Catherine Field Community Submission: July 2022

Submission relating to Minarah College: SSD-30759158

Based on the information provided in the EIS and Supporting Appendices, **the Catherine Field Community object to the development.**

Figure 1: Leppington Precinct- Indicative layout plan⁶ showing 5 possible locations for schools

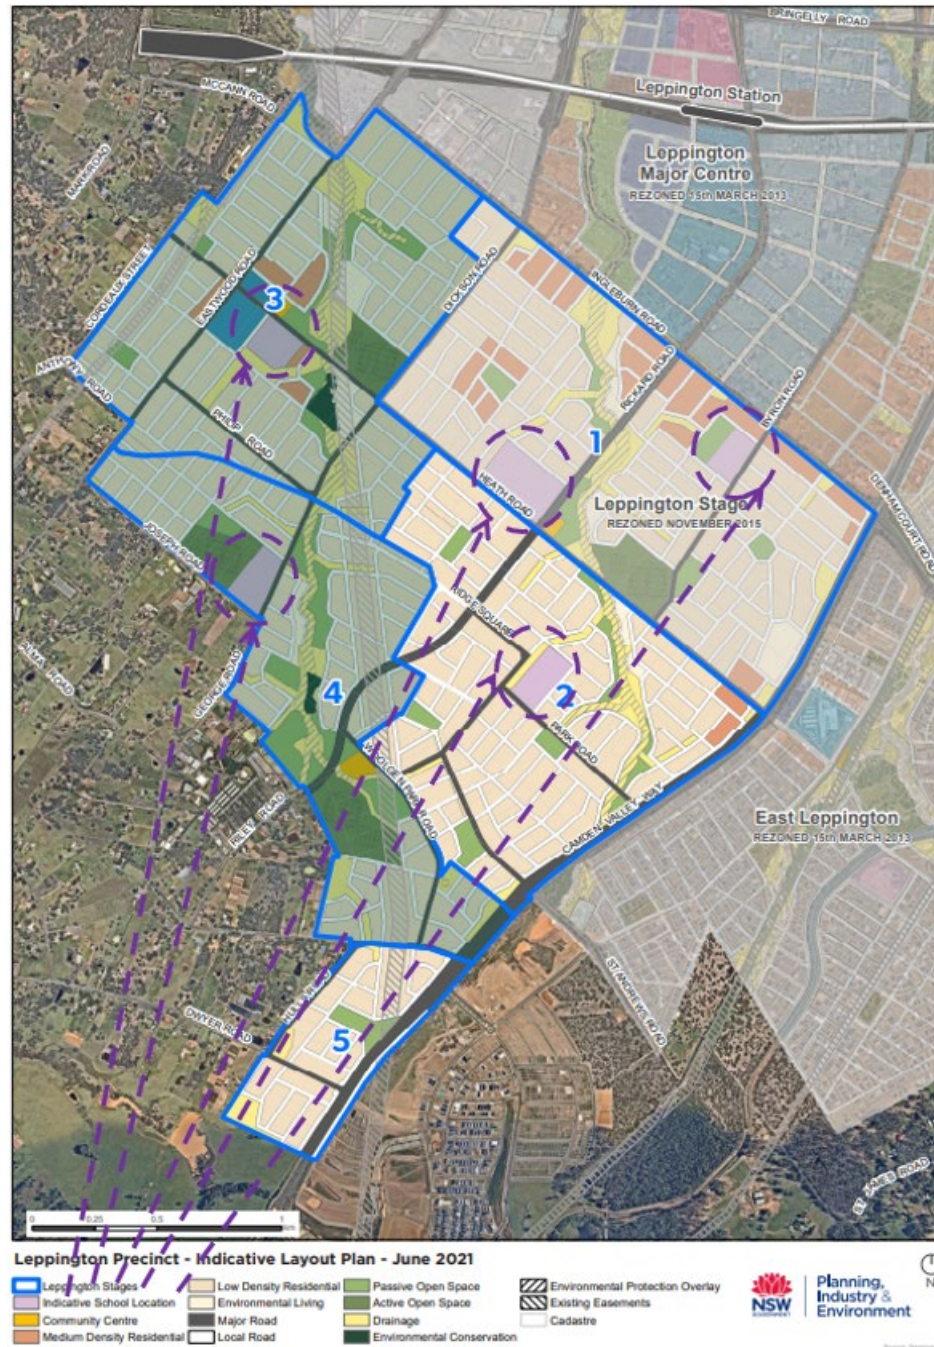
A scenario that has not been investigated is to locate the school in an area that has been rezoned where allotments for schools has already been provisioned. The Leppington⁵ precinct has plans for 5 school locations. Complete with services and a local plan that accommodates schools (for example, schools are located within walking distance of public sporting fields that can be utilized by schools and local

residents. See Figure below extracted from the Leppington Precinct indicative layout plan June 2021. The colored arrows show the location of 5 allotments which are named “indicative school locations”.

The development should seek a location that has plans for schools in their design, complete with infrastructure which will support the school and that the local community will benefit from.
